HYDROLOGY

NEW OFFICE BIDG.

Drawing No.
L14/D1B
Sheet Of
Date
File L14-D1B
JAN 25 10:4
HYDROLOGY SECTION

L14/D1B

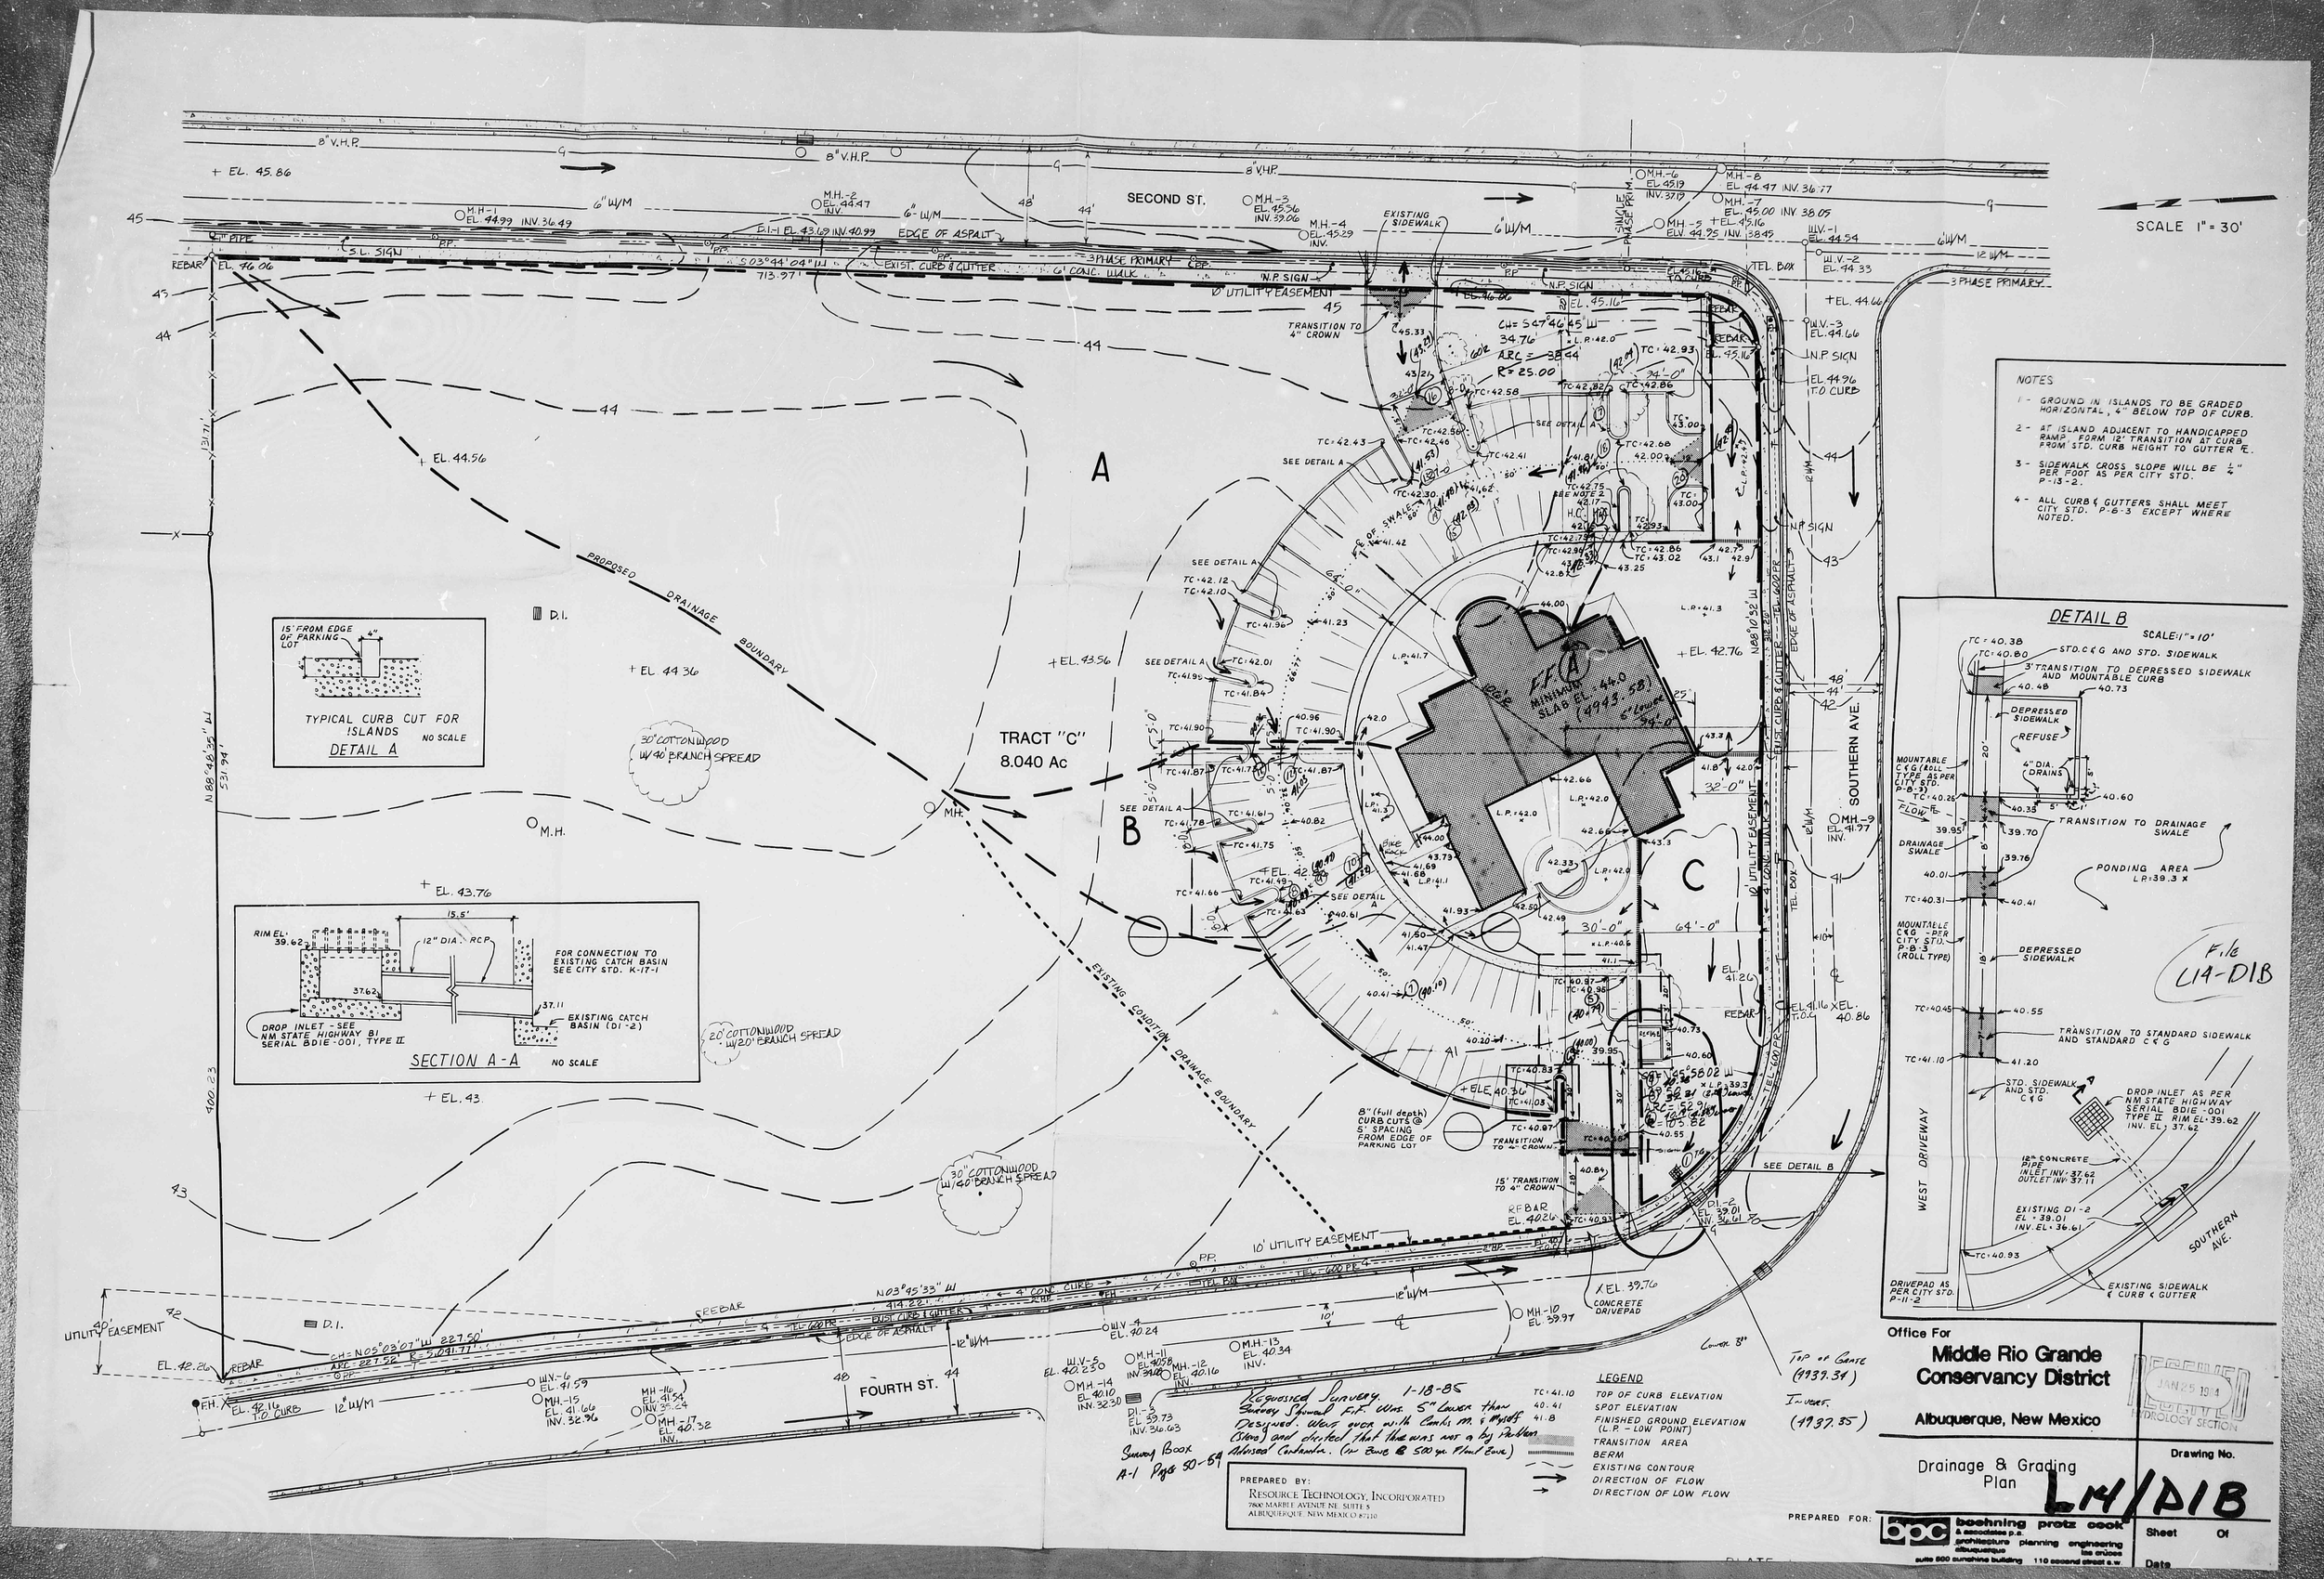
40.41 SPOT ELEVATION
41.8 FINISHED GROUND ELEVATION (L.P. - LOW POINT)
TRANSITION AREA
BERM
EXISTING CONTOUR
DIRECTION OF FLOW
DIRECTION OF LOW FLOW
Requested Survey. 1-18-85
Survey Showed F.F. Was 5" Lower than Designed. Was given with Contr. M. & Myself (Stan) and decided that there was not a big problem. Advised Contractor. (In Book @ 500 yr. Plant Book)
Survey Book A-1 Page 50-54
PREPARED BY:
RESOURCE TECHNOLOGY, INCORPORATED
7800 MARBLE AVENUE N.E. SUITE 5
ALBUQUERQUE, NEW MEXICO 87110
Office For
Middle Rio Grande Conservancy District
Albuquerque, New Mexico
Drainage & Grading Plan
PREPARED FOR:
bpc bohning pratz cook & associates p.a.
architecture planning engineering
albuquerque las cruces
suite 500 sunshine building 110 second street s.w.
